# Rezoning Transportation Analysis

Petition Number: #2022-087

General Location Identifier: 04715204, 04715205, 04715206, 04715208

## Revision Log:

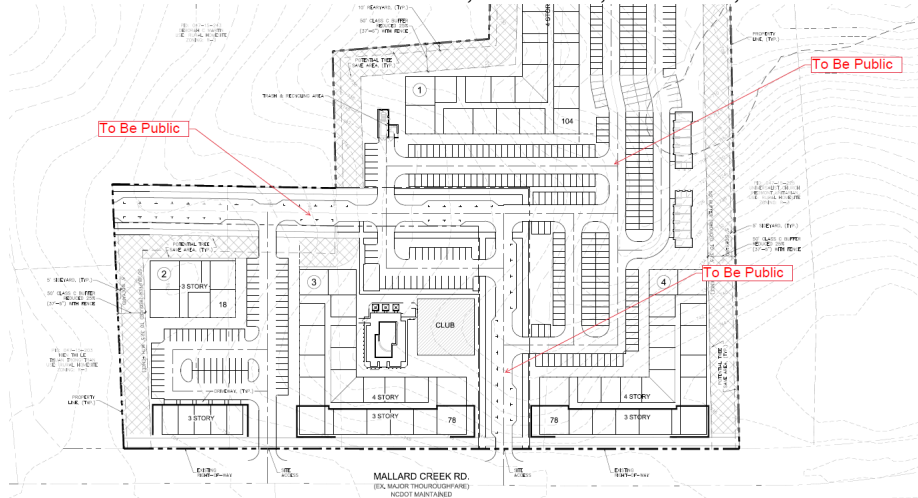
1. ~~**Curbline:** The proposed zoning district has a setback measured from back of the existing or proposed future curbline.~~
  - a. ~~**Mallard Creek Road:** The future location of curb and gutter is measured at 33 feet from the centerline of the roadway to the BOC.~~

Label and dimension the curb and gutter from the centerline for each road on the site plan.
2. ~~**Traffic Study:**~~

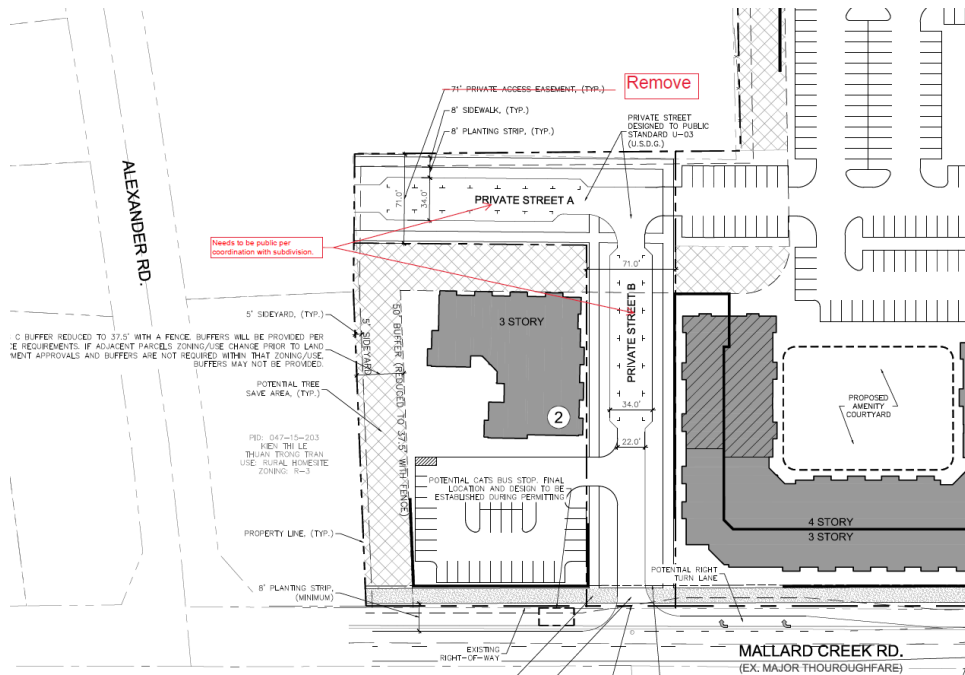
~~Clarifying comment from 12/22/2022: Private Street A and Private Street B will both need to be public streets per coordination with subdivision. Remove all references to private access easements for Private Streets A and B.~~

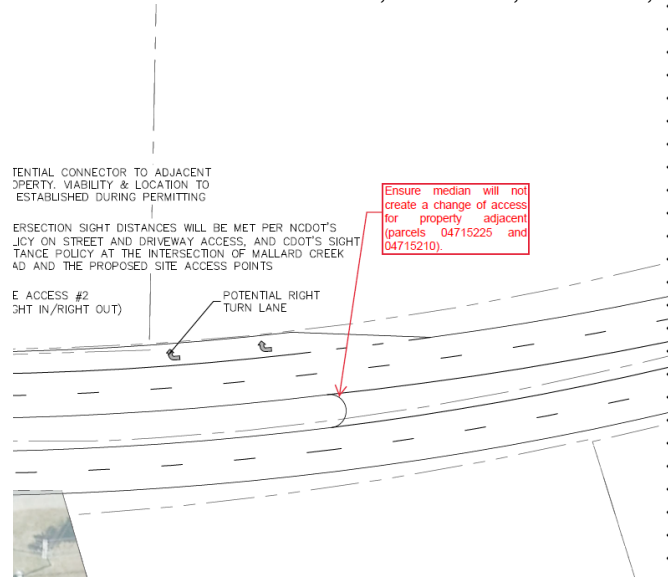
~~5. New comment from 12/22/2022: Modify median to ensure full movement for development adjacent can be retained from parcels 04715225 and 04715210. What is being proposed will create a change of access for the development adjacent to property.~~

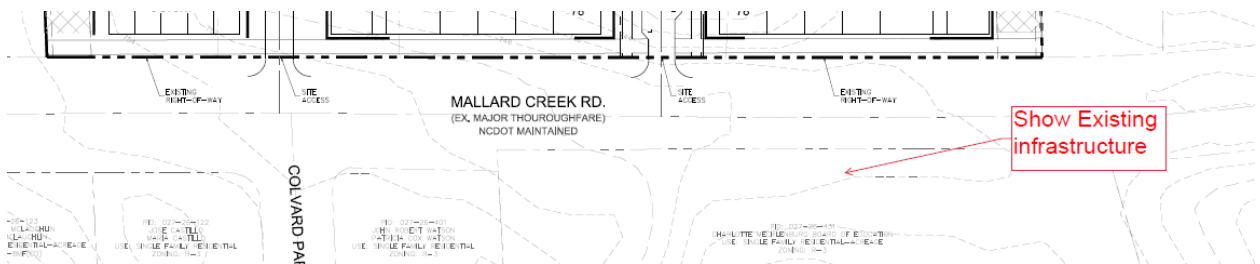
- 6. ~~The proposed dwelling units exceeds 12 per acre. Per Chapter 20 Subdivision ordinance, site plan and conditional note(s) revisions are needed to commit to construct an 8-foot planting strip, and 8-foot sidewalk along all internal public roads. The wider sidewalk also meets the Charlotte WALKS Policy.~~
- 7. ~~Revise site plan and conditional note(s) to commit to construct an 8-foot planting strip, and 12-foot sidewalk along the sites frontage per Chapter 19. The site plan shall label and dimension both items from the back of curb and gutter and road centerline.~~
- 8. ~~Revise site plan and conditional note(s) to commit to the southern site access as right in or right in/right out only. The northern site access at Colvard Park Way may be constructed as full movement. Site plan shall callout access restrictions of both site entrances.~~

~~Modify conditional note to specify that final design and location of southern driveway access will require additional coordination during permitting and may require infrastructure changes such as re-striping and/or concrete medians.~~
